WCAP 8587

EQDP-ESE-6

Resistance Temperature Detectors: RCS Well Mounted

Revision 5

Figure 4. Typical Combined LOCA/SLB/FLB Test Envelope

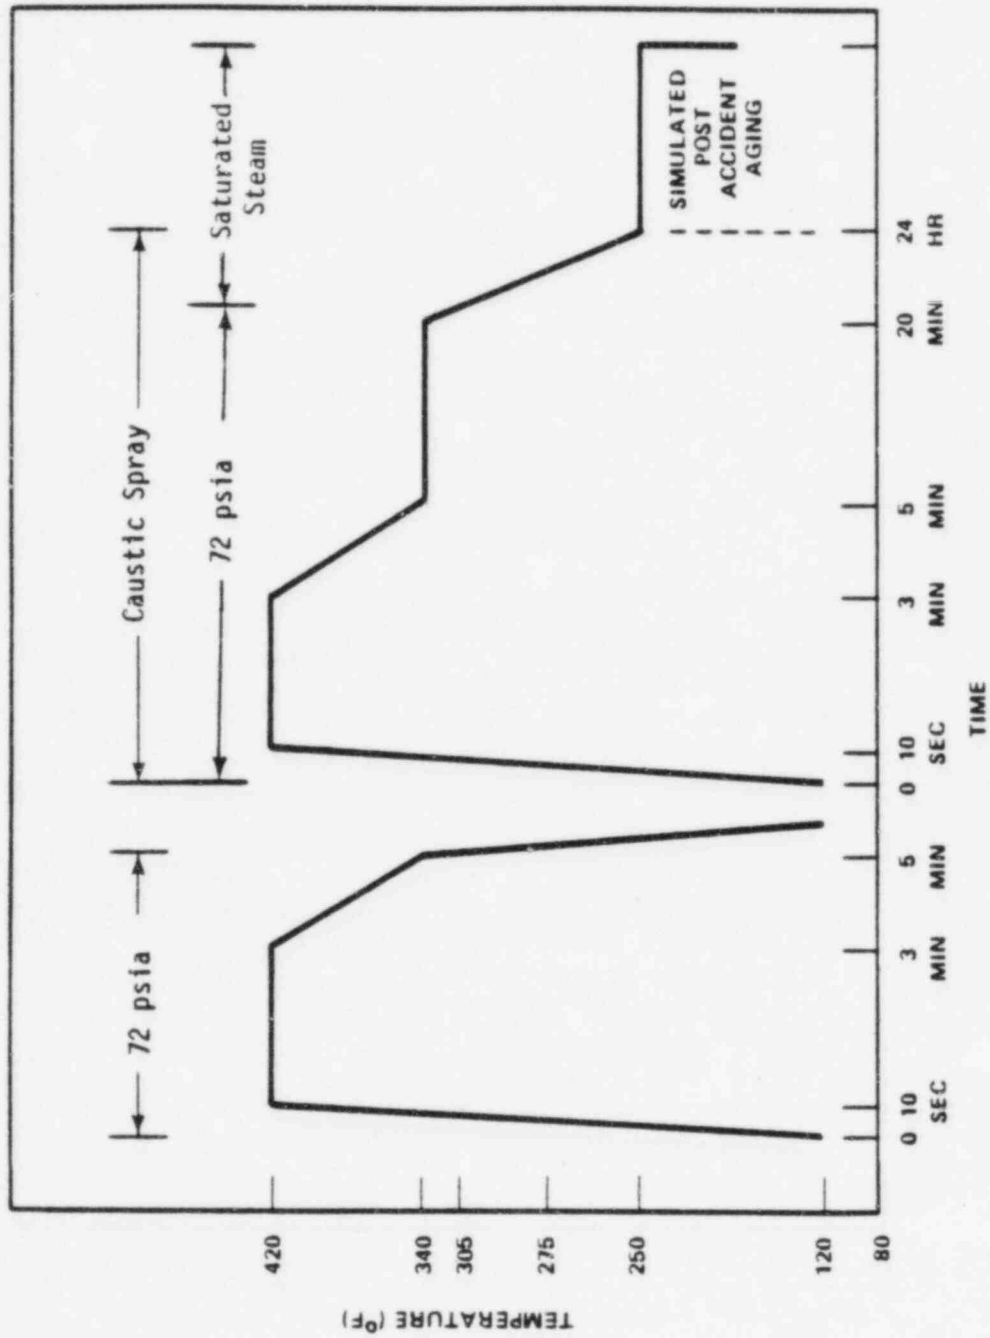
The well mounted RTD's were subjected to the HELB simulation temperature profile of Figure 4. | 5

Following the 420°F temperature peak, the temperature gradually declines to 250°F and is held at saturated steam conditions for 15 days, simulating a four-month period of post HELB operation.
